# Technical Service Information

## SUBARU 3 SPEED SLUGGISH AFTER SITTING OVERNIGHT

Figure 1

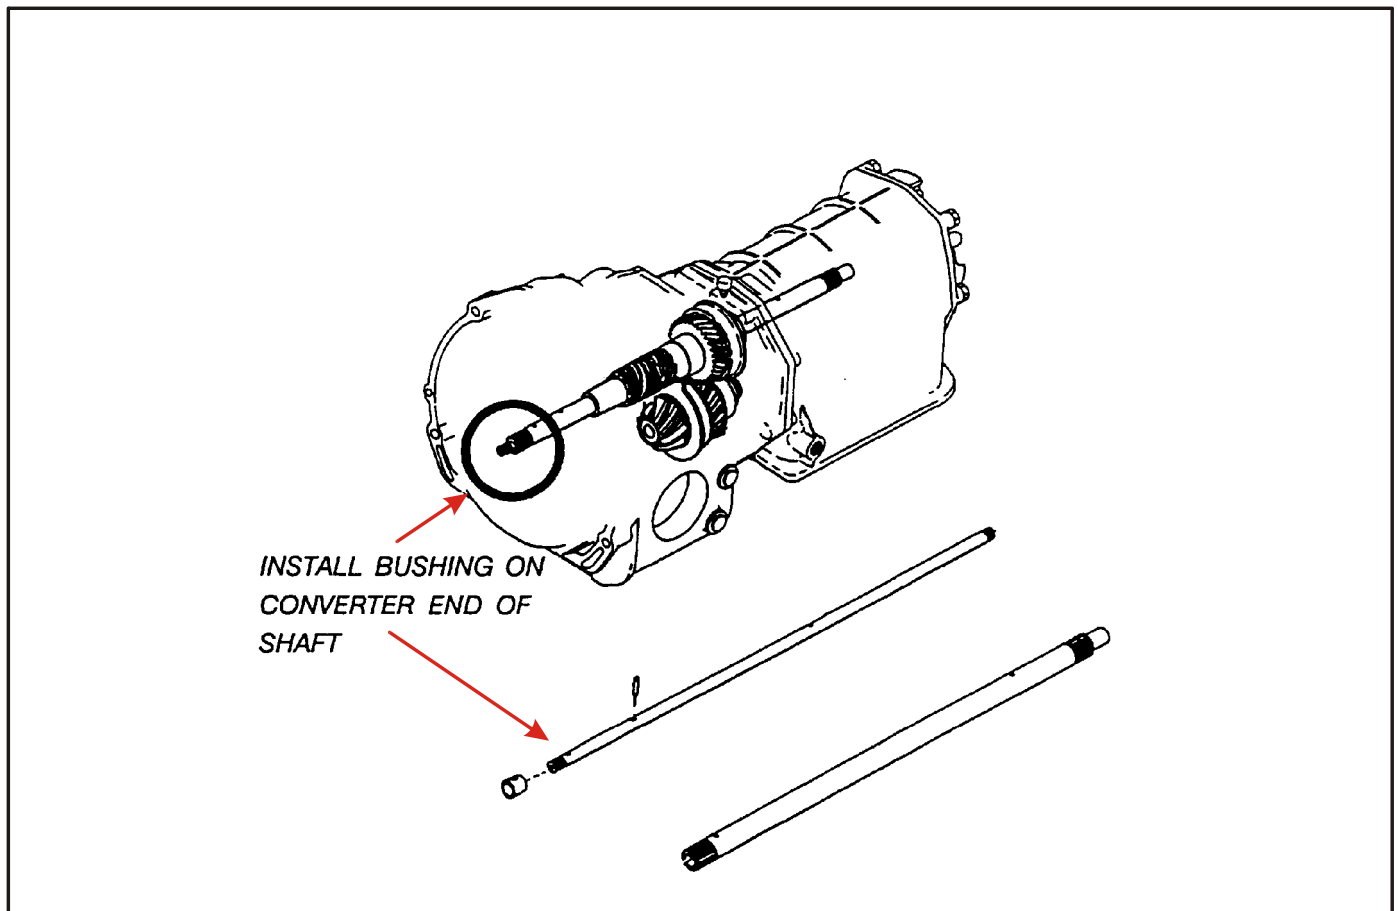
- COMPLAINT:** Transmission works fine until it sits, with the engine off, for a period of an hour or more. When started you have a slip and/or extreme sluggishness.
- CAUSE:** Oil pump drive shaft bushing has been installed on the wrong end of the shaft, or is missing, creating converter drain back and requiring fill time for the pump to refill torque converter.
- CORRECTION:** Install the oil pump drive shaft bushing into "Converter End" of turbine shaft, between turbine shaft and oil pump drive shaft (Refer to figure 1).
